Independent Rapid Assessment of the Parramatta CBD Planning Proposal for DPE

1st March 2022

Bennett and Trimble

3. Recommended Height Controls

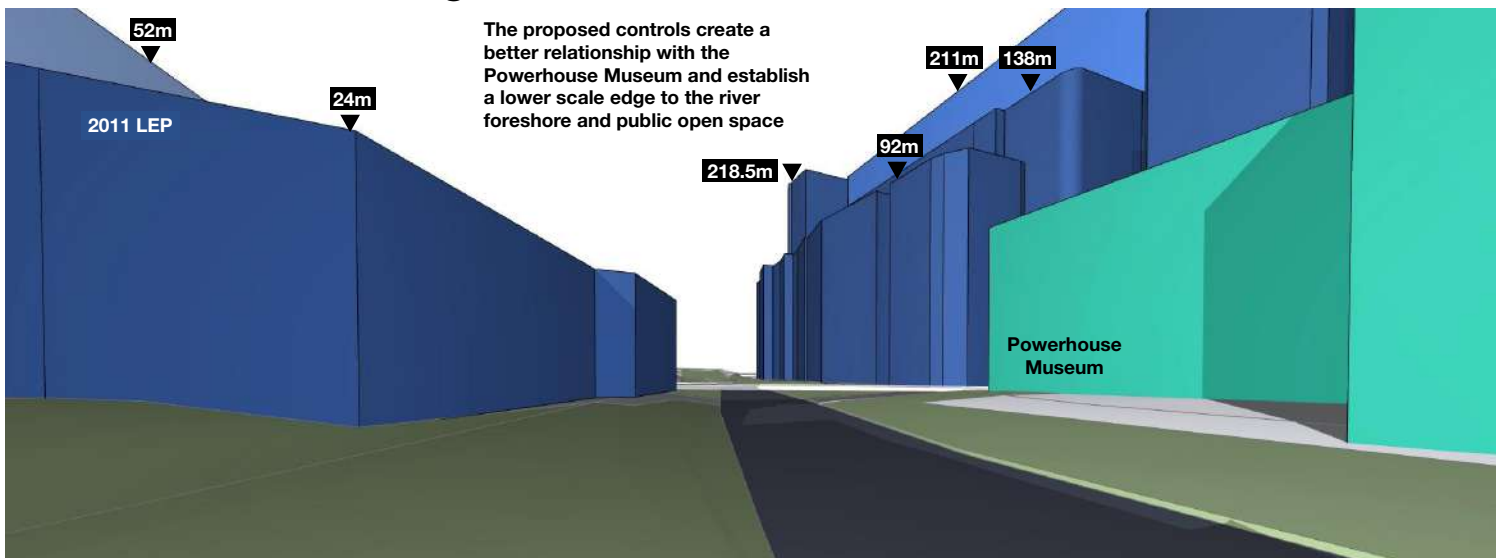
Parramatta has a unique relationship with its river and the current Planning Proposal risks jeopardising this relationship for future generations.

The relationships between the recently completed tall buildings and the river is unconvincing. They appear to commercialise the foreshore and visually dominate the river corridor. This type of development is similar to Southbank in Melbourne or Barangaroo in Sydney, and may not offer the most sensitive or place-specific response that Parramatta deserves.

Any additional height or FSR (including incentives) allowed as part of this Planning Proposal should be removed to the sites along the southern foreshore.

The height plane controls to the north of the river should be reconsidered and consolidated to establish more consistent building heights that step down to the river to mitigate bulk, and maintain or improve solar access and sky views from the foreshore and Civic Link.

Western Alignment Summary

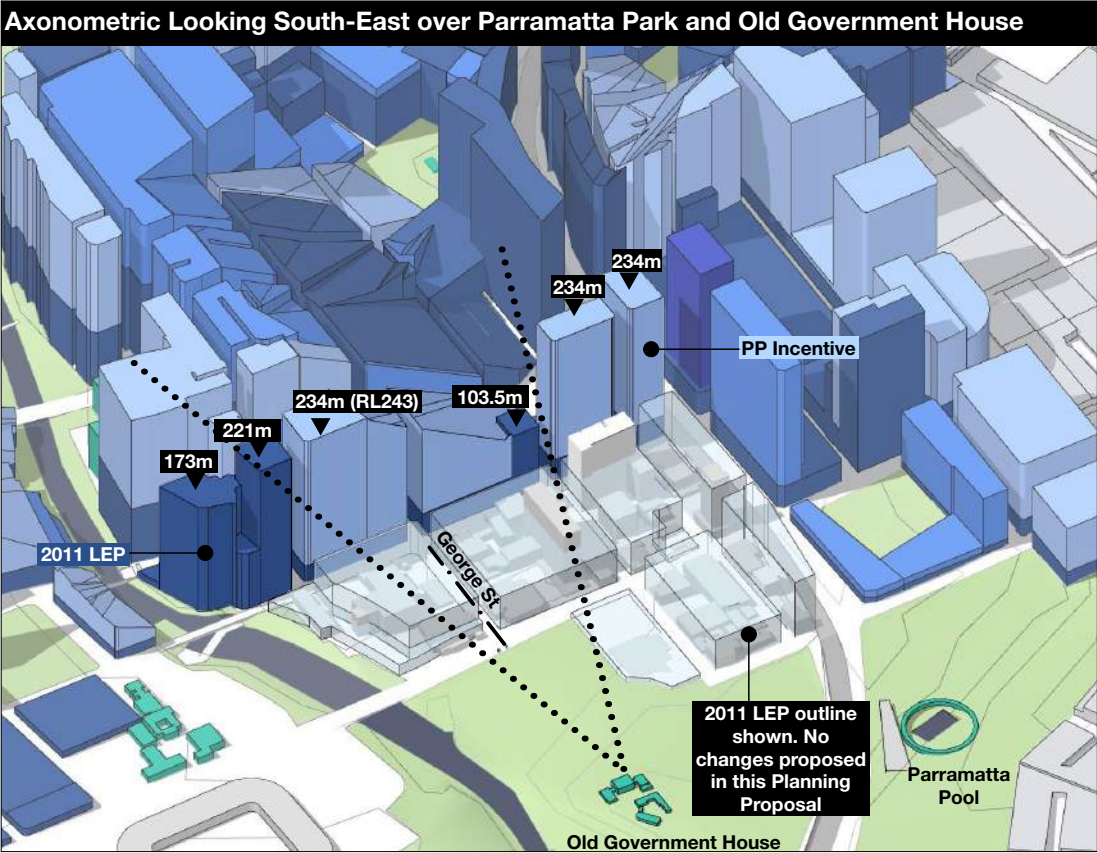
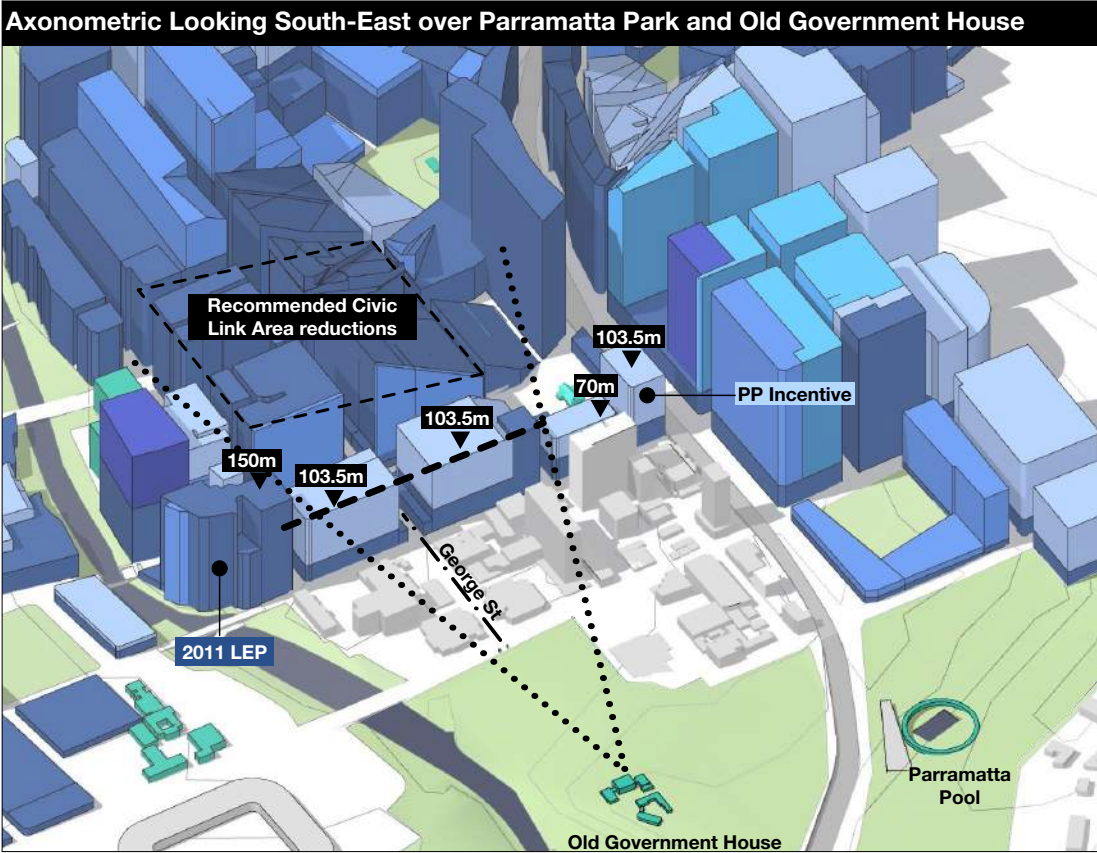
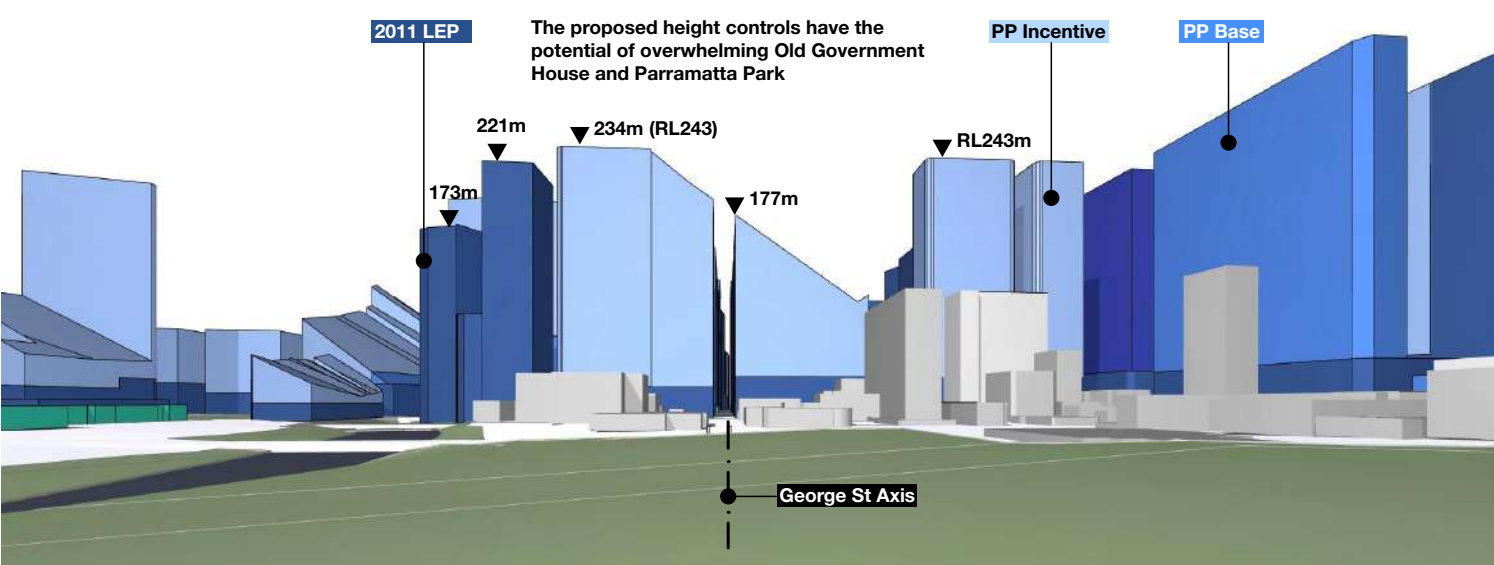
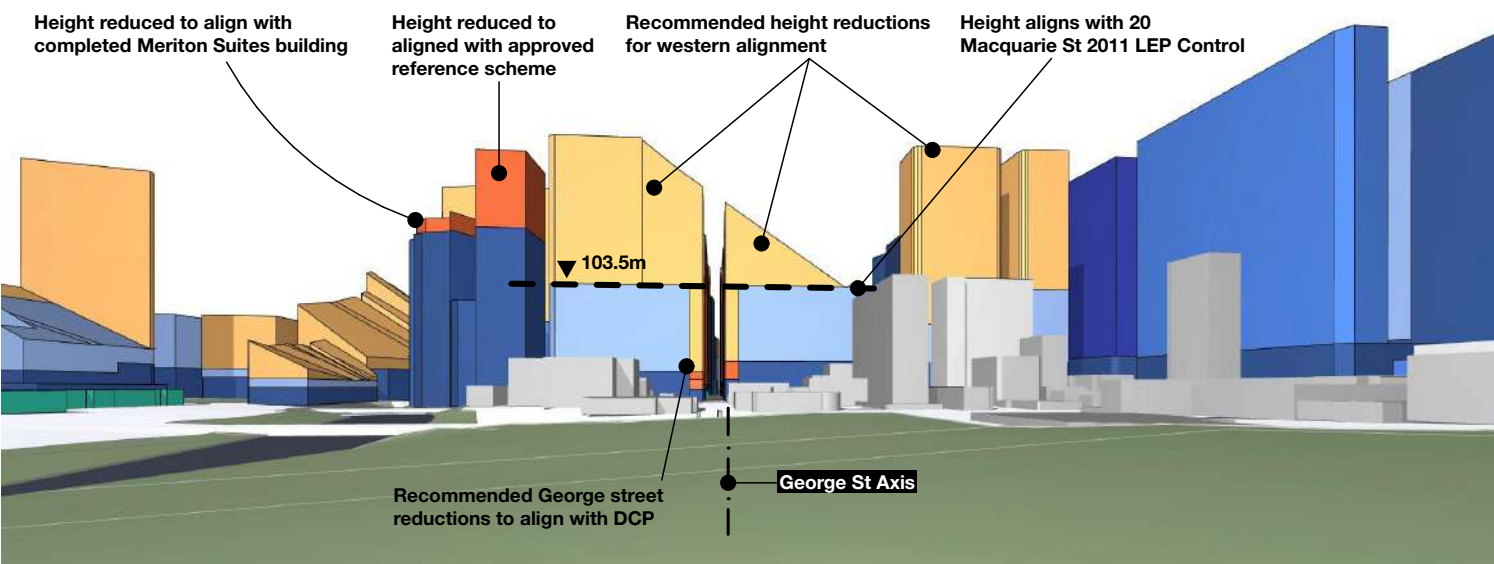
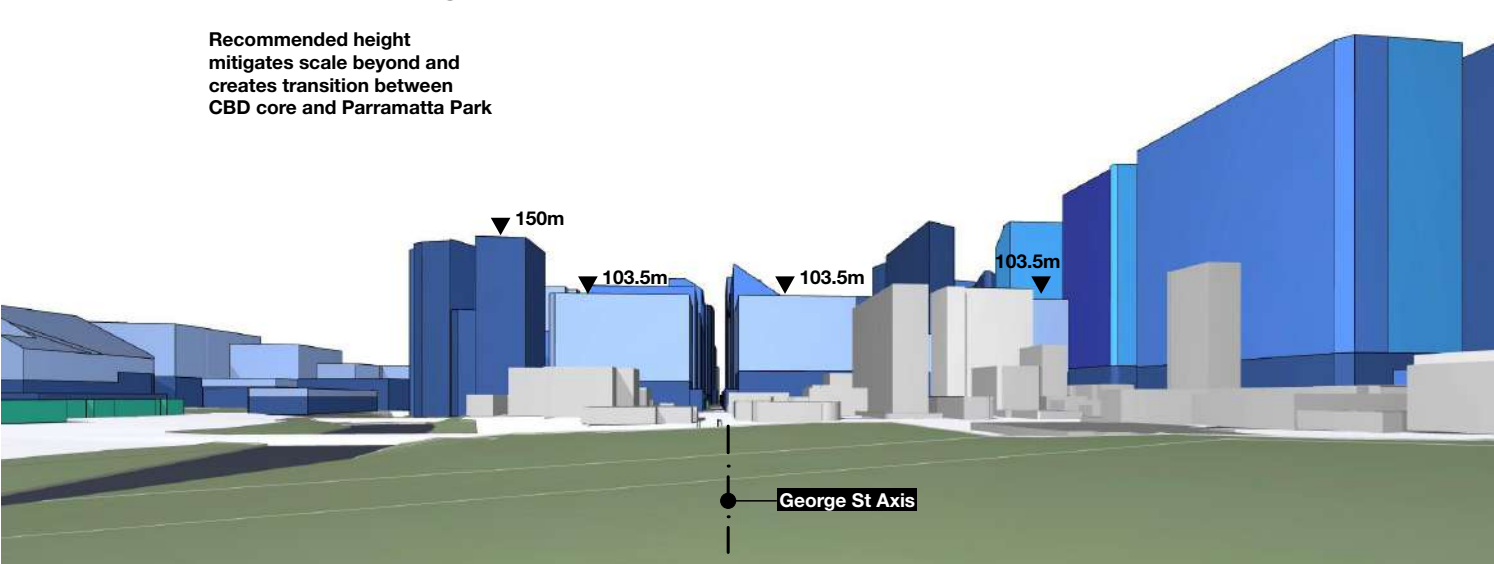
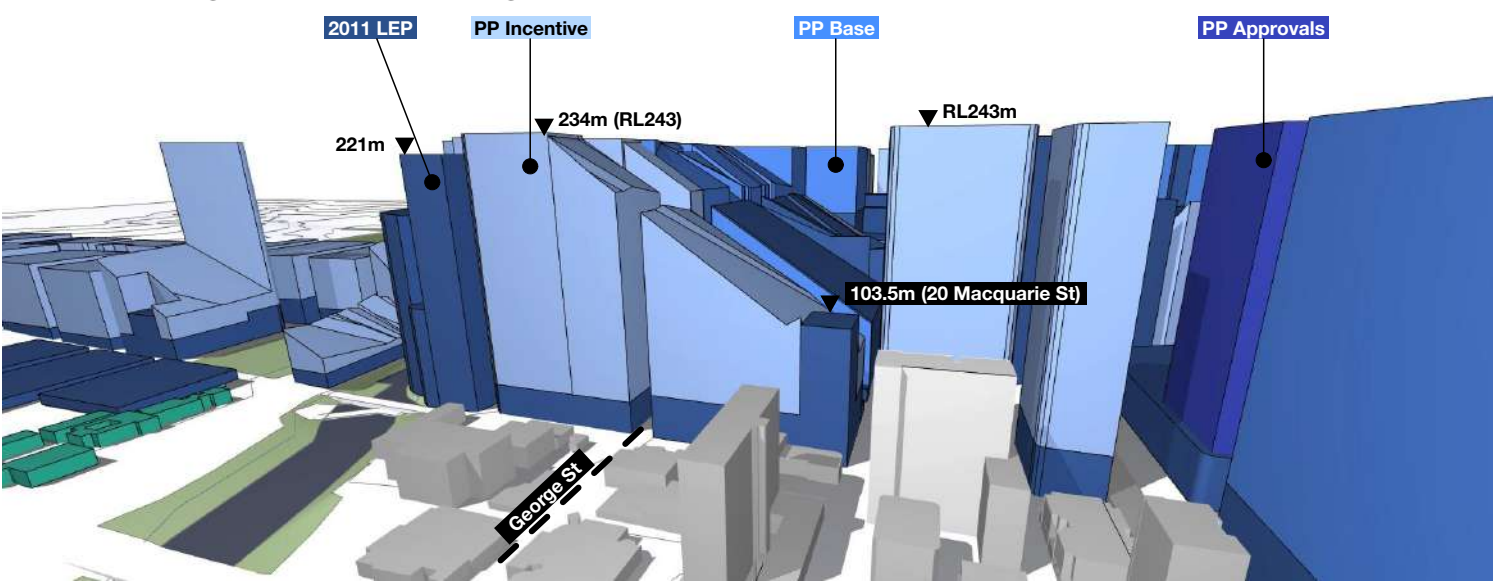
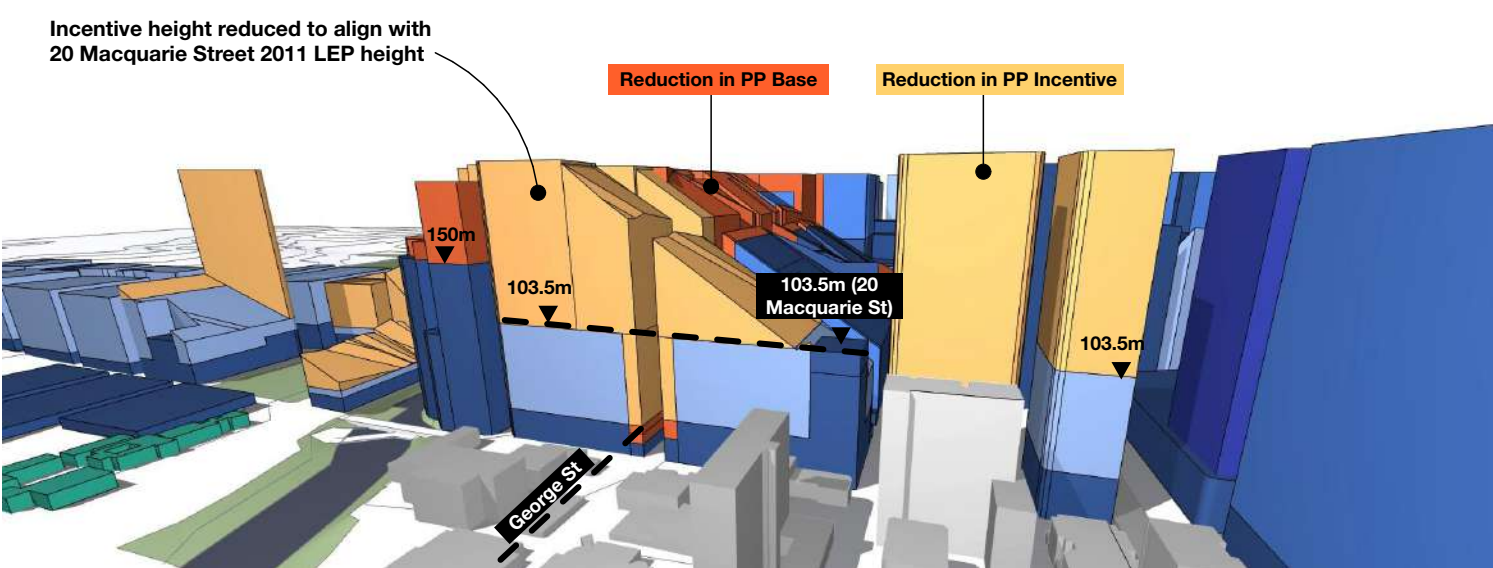
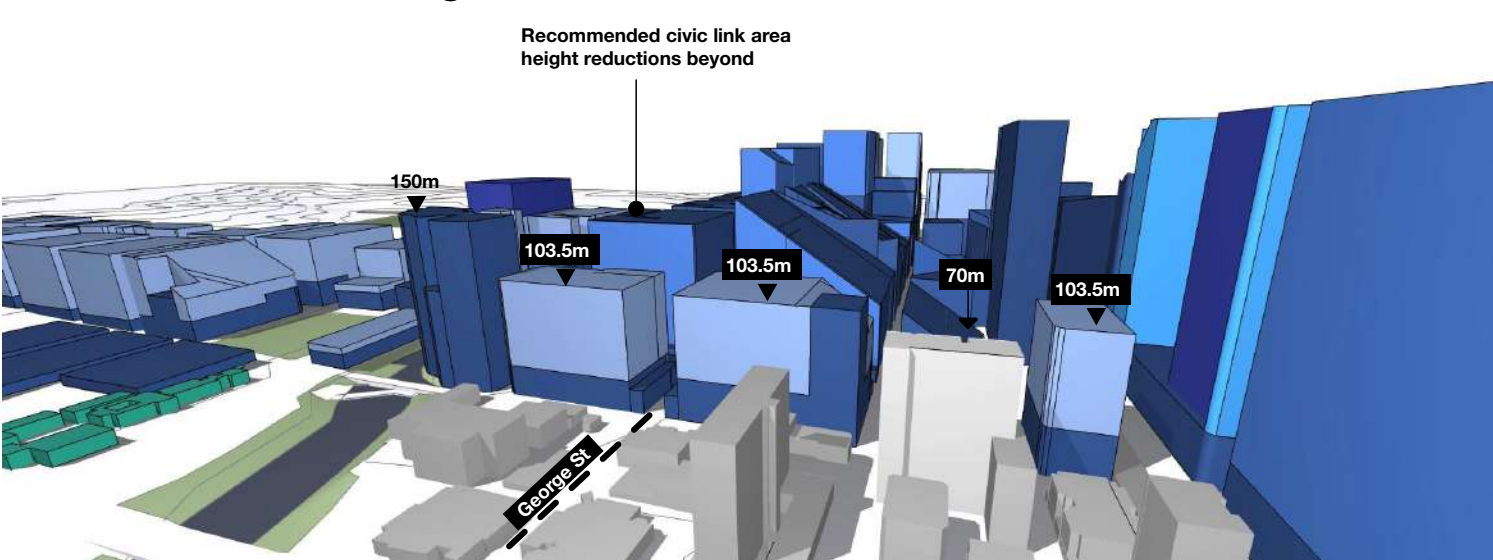
The proposed height controls between Marsden and Church St are defined by the maximum permissible height and the solar plane to Parramatta Square. The resulting forms appear as a simple cropped extrusion and establishes an abrupt, simplistic and unsympathetic interface with the adjoining area.

These blocks also contain a number of approved planning envelopes including a completed building at 150m on the riverfront that is visible when viewed from Old Government House.

Where possible, the incentive height controls for the blocks between Marsden and Church Street should be reduced to create a transition in height between the sensitive areas to the west and future CBD development to the east. This transition in height should also be used to establish a consistent and legible urban edge to the commercial precinct.

For the two blocks between Marsden St, Church St, Phillip St and Macquarie St, the incentive height controls should be reduced to align with the approved planning proposal for 22 Macquarie Street to establish a height datum of 103.5m (inclusive of Design Excellence). The height controls south of Macquarie St should step down to 70m to increase solar access to Centenary Square and then step up to 103.5m to mediate the increased heights to the Aird Street Retail Area.

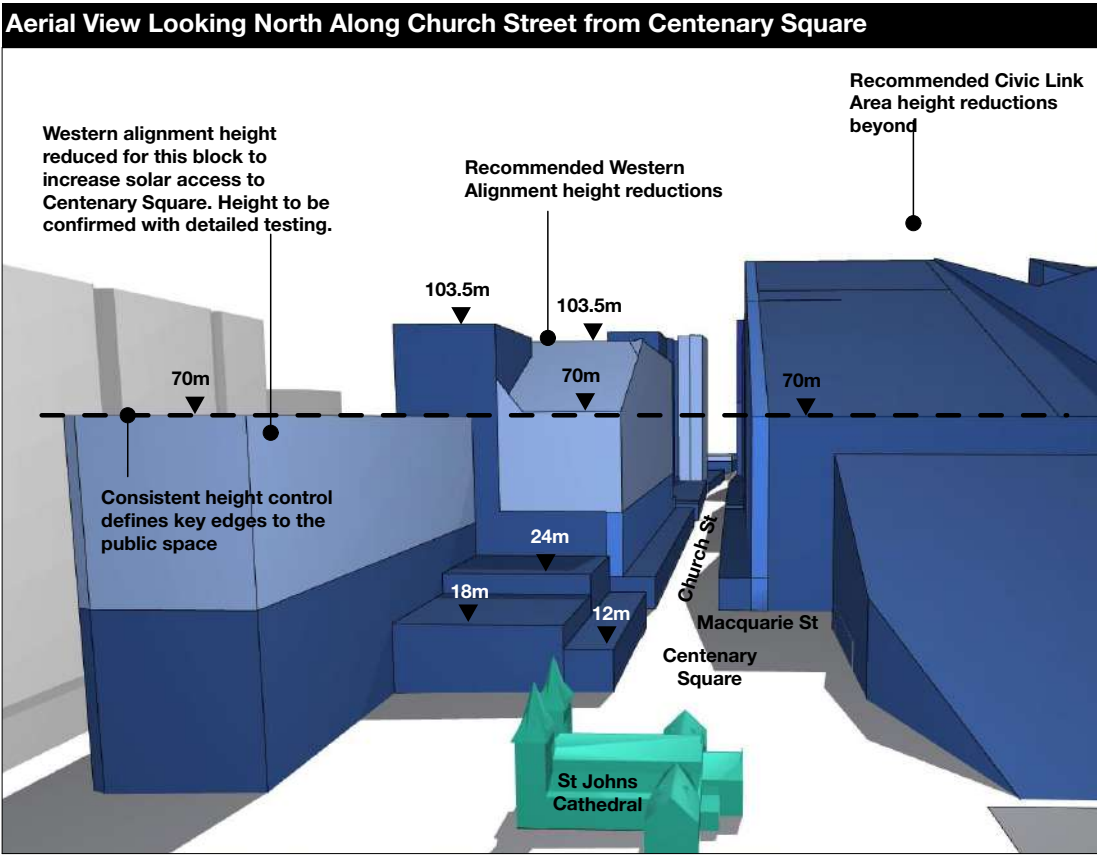
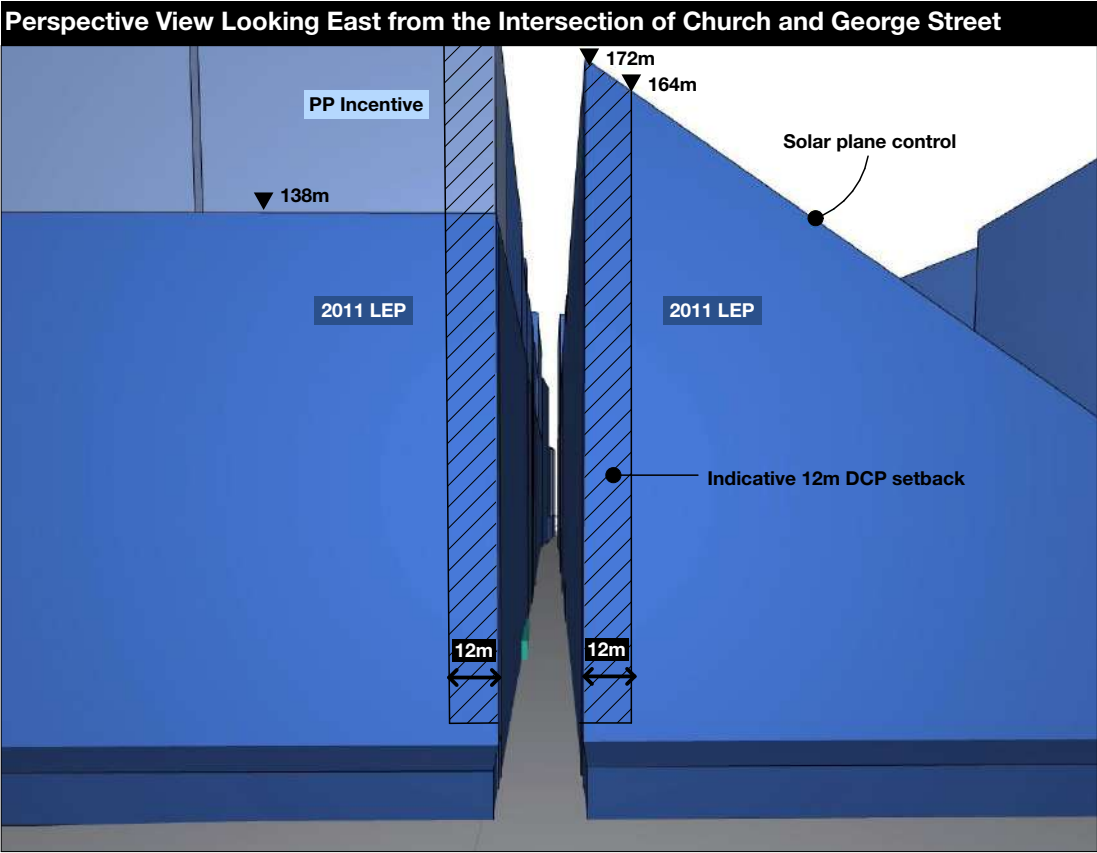
Church Street is one of Parramatta's most active and vibrant streets supporting a range of outdoor dining opportunities. While the LEP and DCP seeks to retain and reinforce its fine grain, scale and pedestrian character, earlier proposals for solar protection to this important public realm have not been adopted within this Planning Proposal.

The recommended decreases in height controls in this assessment to the western CBD alignment as well as the decreases in height controls to the Civic Link area provide an opportunity to establish solar controls to both Centenary Square and Church Street to preserve and protect the excellent amenity they currently enjoy.

Test the increase in solar access and sky view for both Church Street and Centenary Square provided under the recommended reductions in height controls to the surrounding blocks.
